SDR PCB and Schematics Corrections for YU1LM/QRP Projects

Here is list of all my errors in my 3 articles which I knew in this moment. I am so sorry for them and I am apologizing to all for inconveniences. I also want to thank you to all who send me messages about my designs and especially for mistakes which you have found.

1. First part:

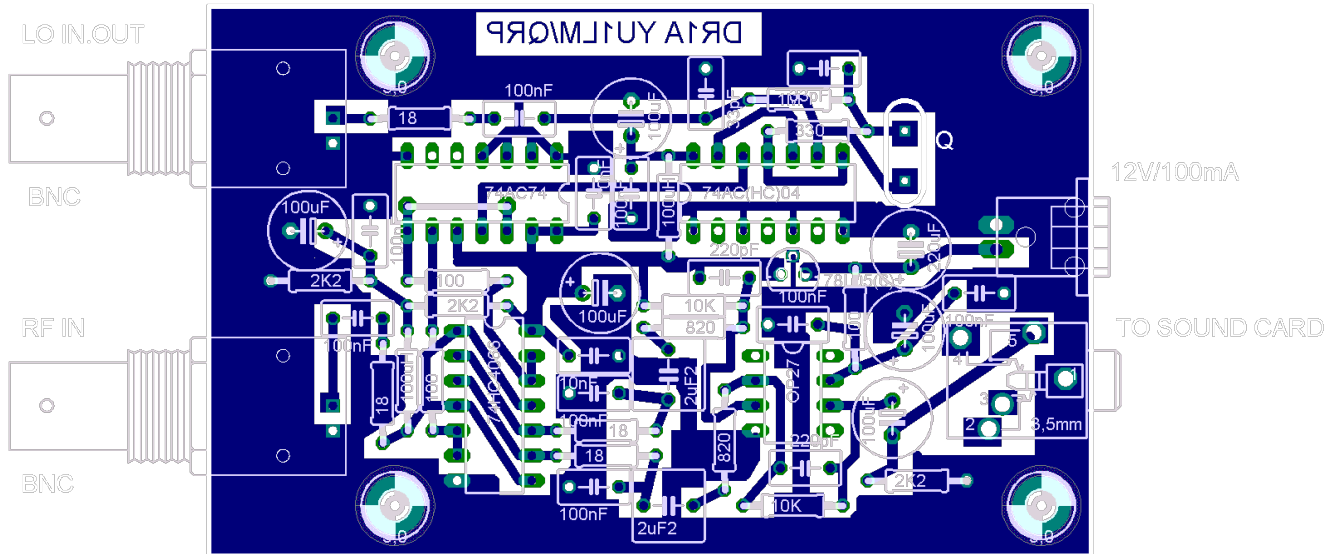
- in DR1 78L05 is not oriented correct (turn on it for 180 DEG and shape GND pin)
- In schematic VCC for 74AC02 I missed one choke 100uH, 100uF and 100nF
- better values for R7, R8 are 1K instead 2K2, better $\frac{1}{2}$ VCC divider
- better values for R11, R12in DR2 are 1K instead 2K2, better $\frac{1}{2}$ VCC divider

2. Second part:

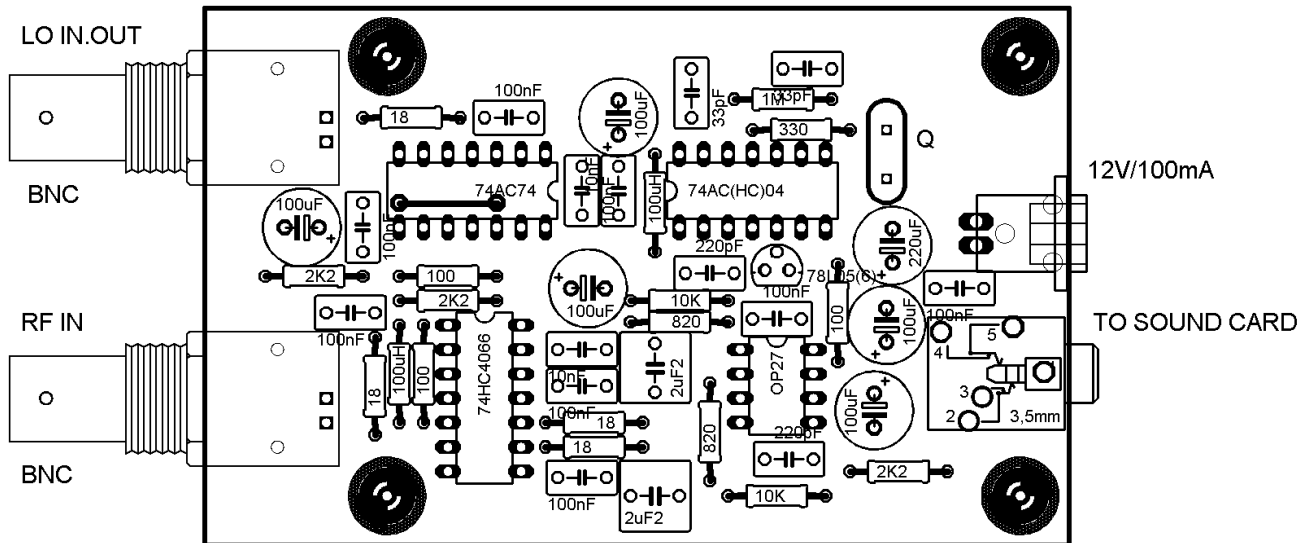
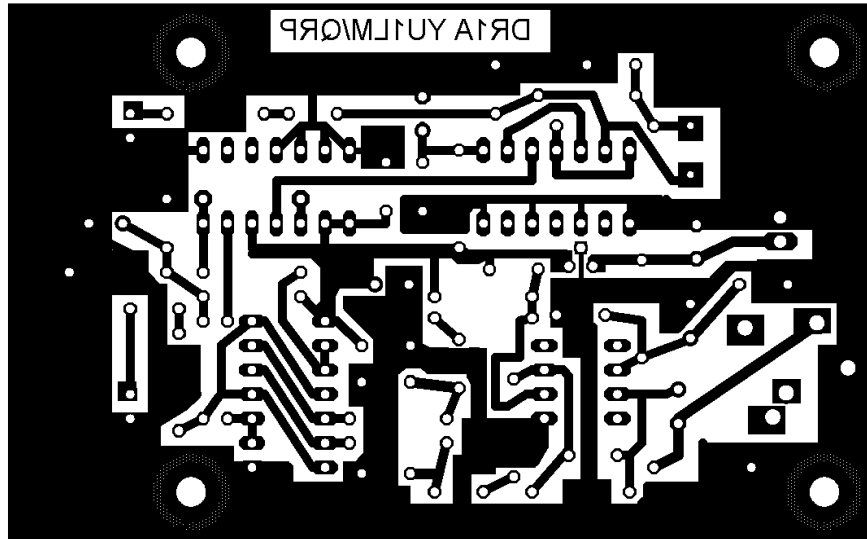
- for IC1 74HC4066 I missed choke 100uH, 100uF and 100nF in +VCC branch

HF I/Q SDR Transmitter DT2A

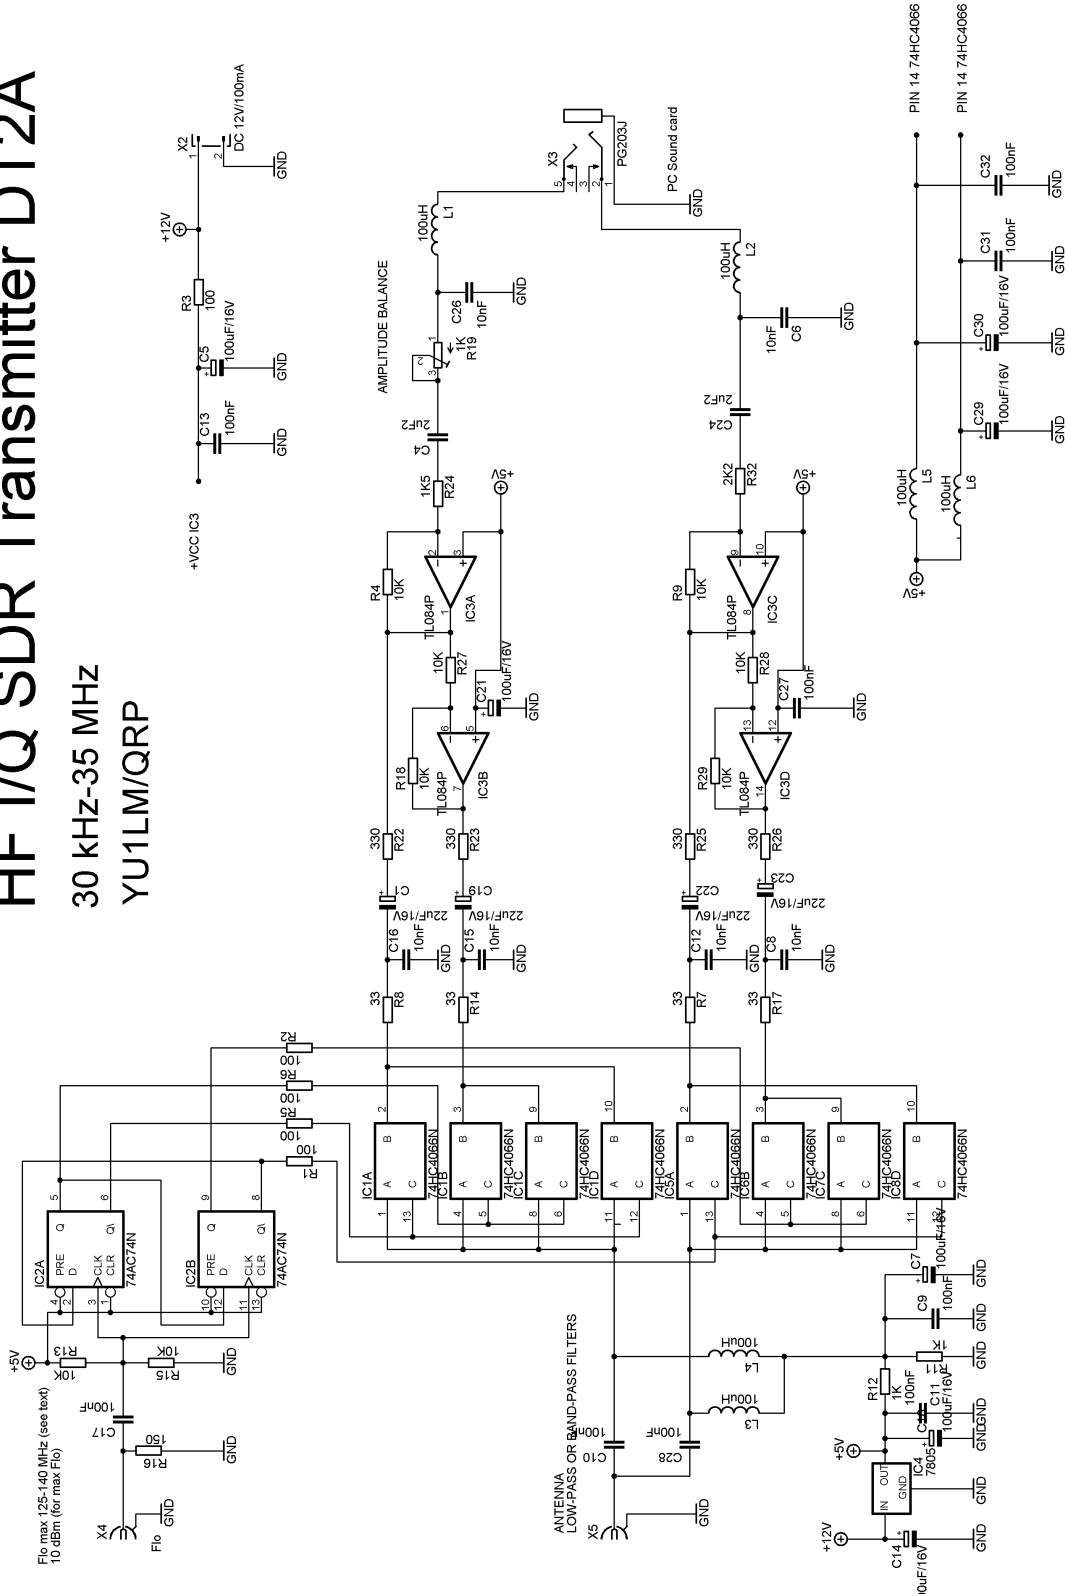
For DT2A SDR Transmitter I published wrong version of schematics. Correct schematic is shown down and PCB published previously was for the DT2A transmitter.

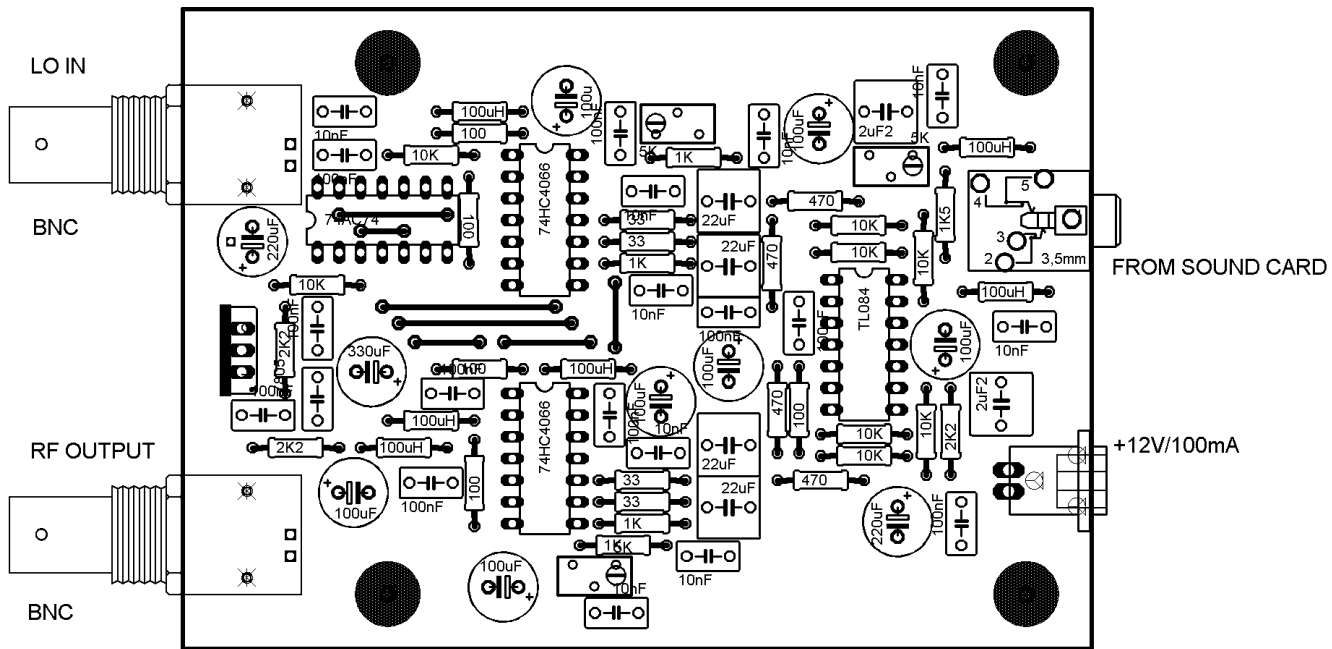
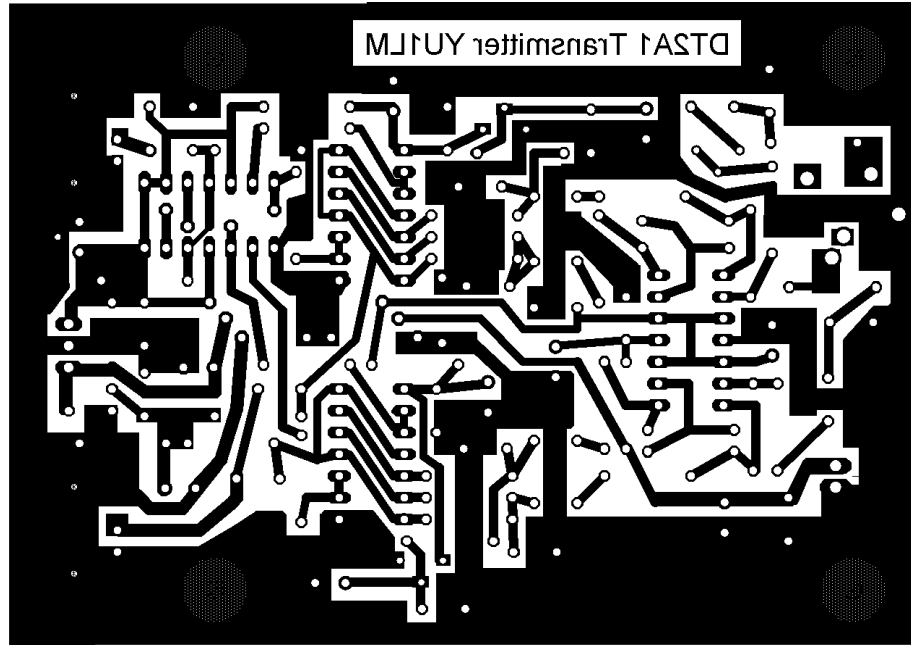
DR1A correct schematic PCB is down (I turned for 180 DEG 78L05)

PCB and parts placement at site article is for this schematic up. DT2A schematic at site is DT2A1 version of DT2A and PCB for it is down with parts placement. I also propose new PCB with lower LO leakage and better LO suppression than original DT2A.
